CLIENT: Caivan (Orleans Village 2) Ltd
2934 Baseline Road, Suite 302h
Ottawa, ON
K2H 1B2

SITE: 245-275 Lamarche Ave

TITLE: Geometric Road Design
Redline

SCALE AT A3: NTS	DATE: 2022-12-09	DRAWN: BB	CHECKED: AL
PROJECT NO: 2022-023	DRAWING NO: 001	REVISION: 04

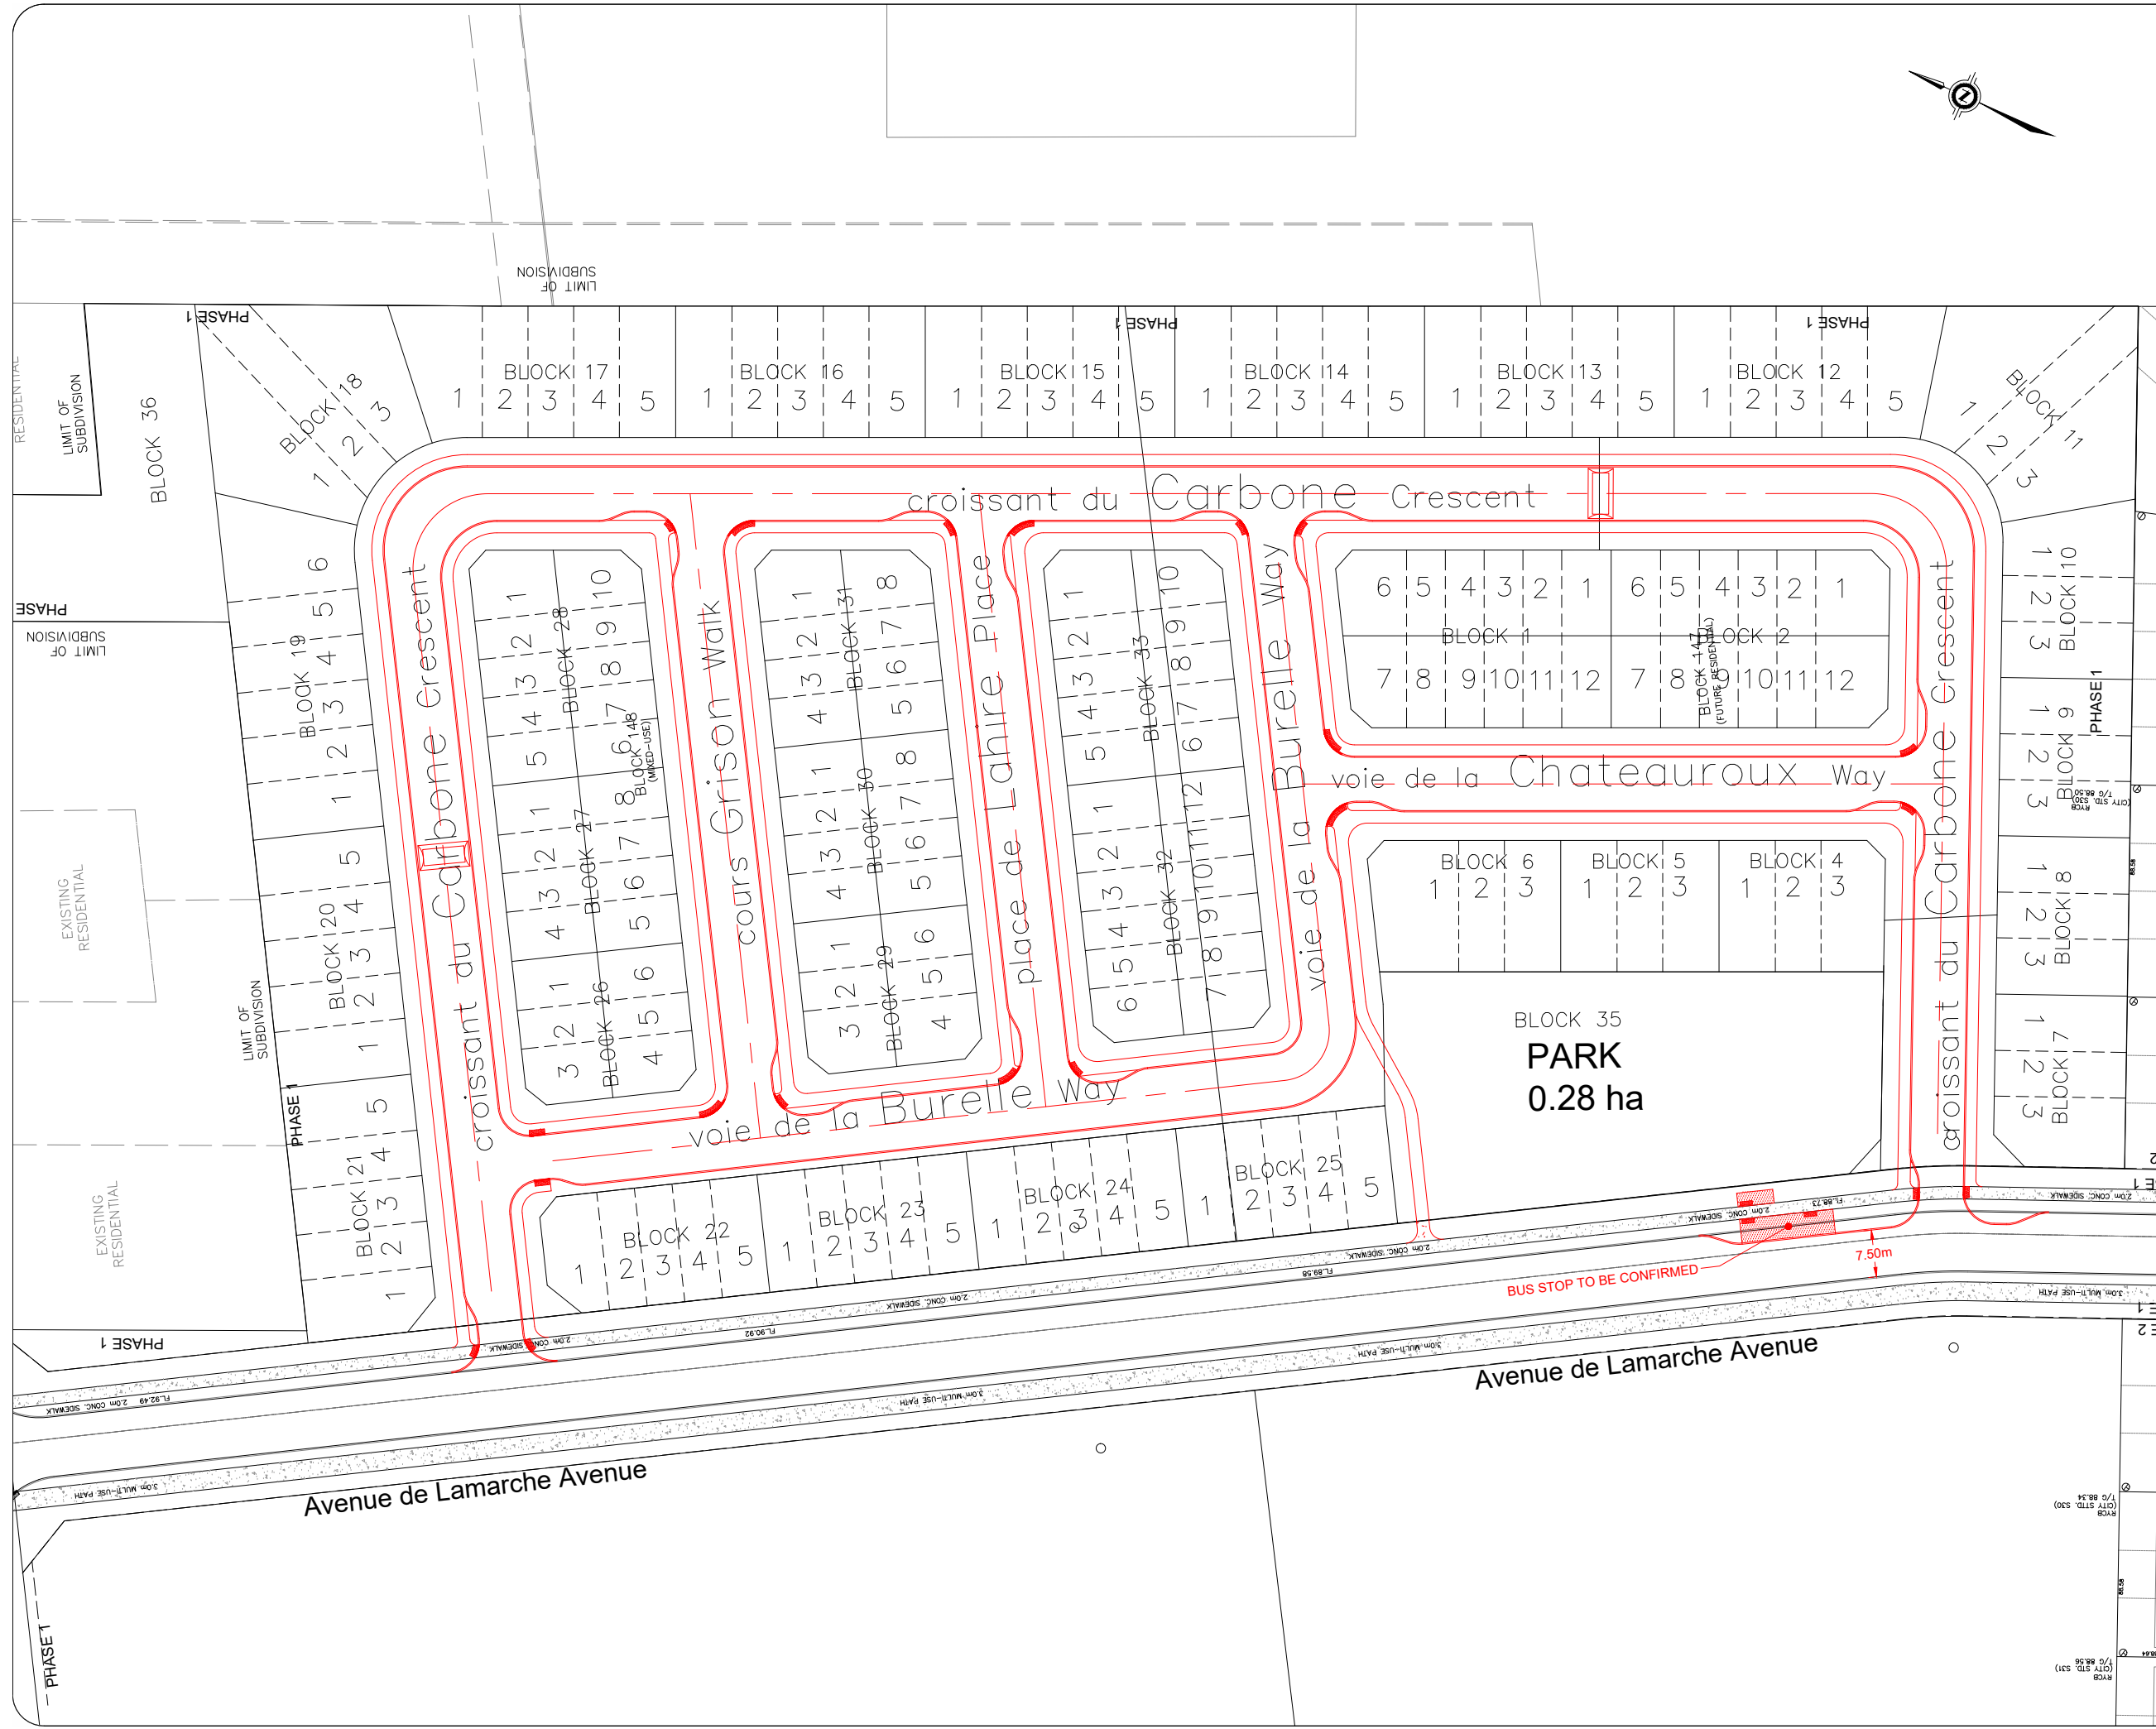
BUS STOP TO BE CONFIRMED
